**AMENDMENT 5**

**Invitation for Bid (IFB)  
UOG IFB No. B23-01**

UOG INVITATION FOR BIDS NO. B23-01:  
MULTI-STEP SEAL BID FOR CONSTRUCTION SERVICES

**QUESTION & ANSWER SHEET NO. 3**  
**July 25, 2023**

**1 FIRST FLOOR POWER PLAN**  
2EP101 1/8" = 1'-0"

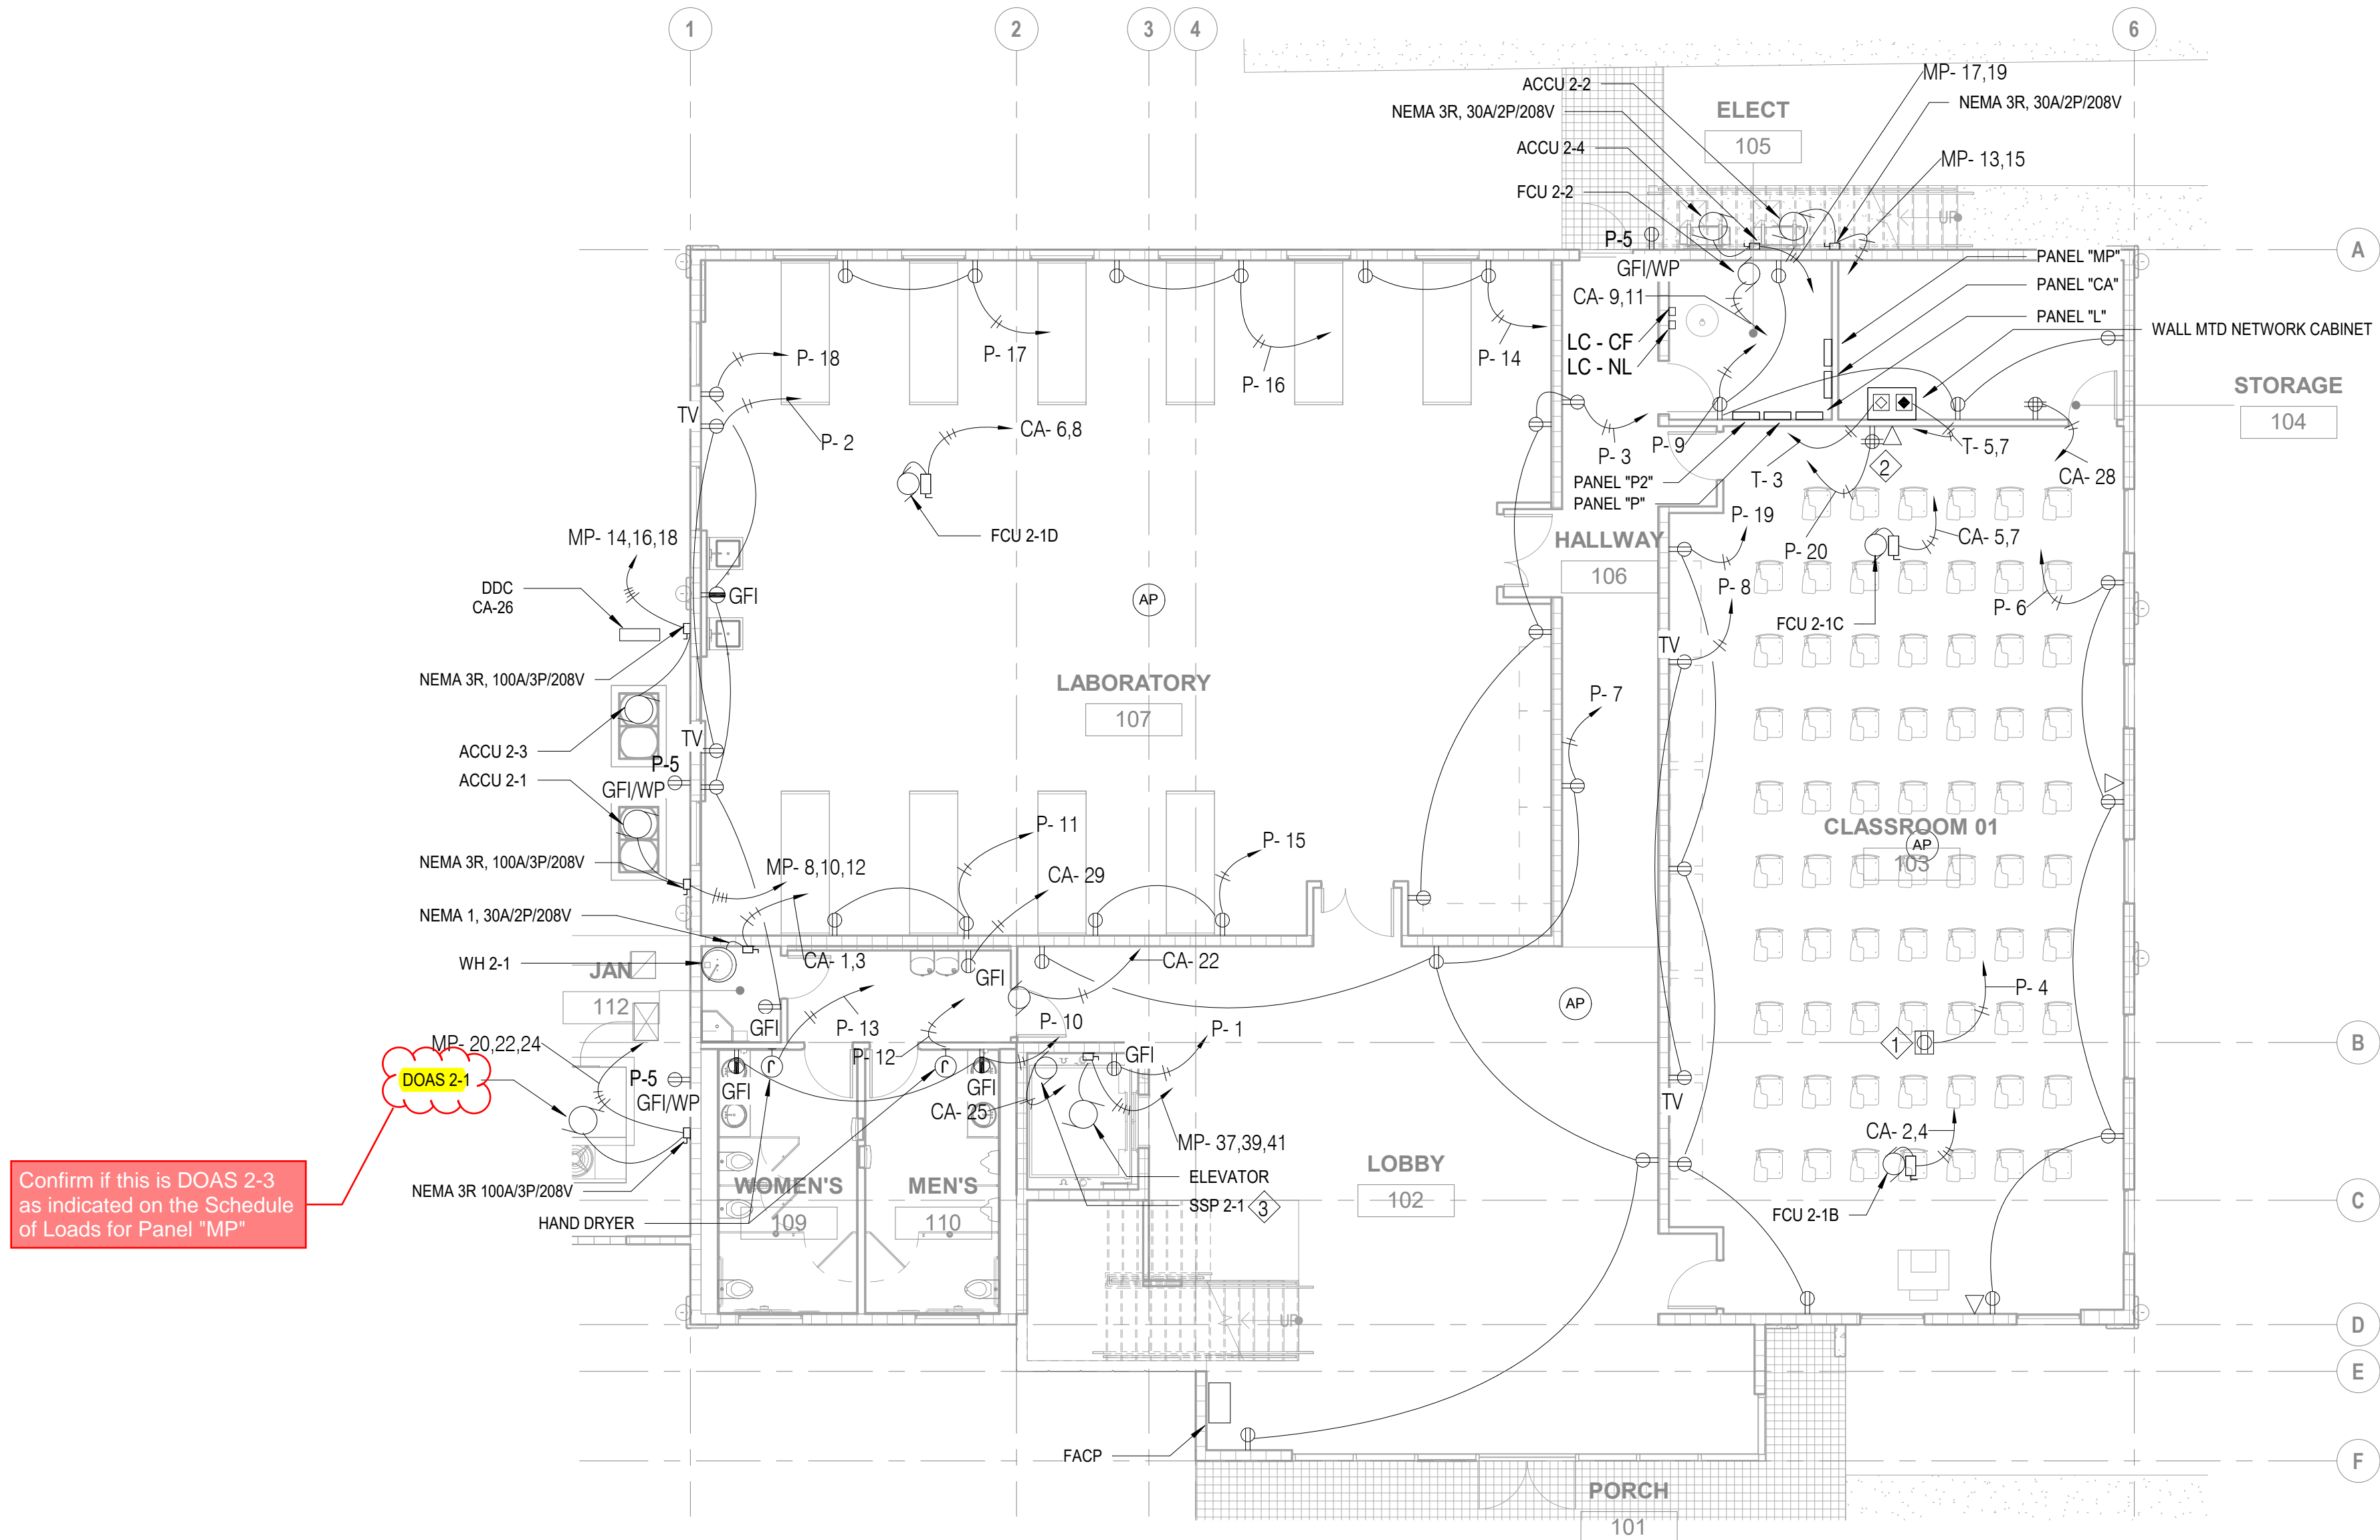
Confirm if this is DOAS 2-3 as indicated on the Schedule of Loads for Panel "MP"
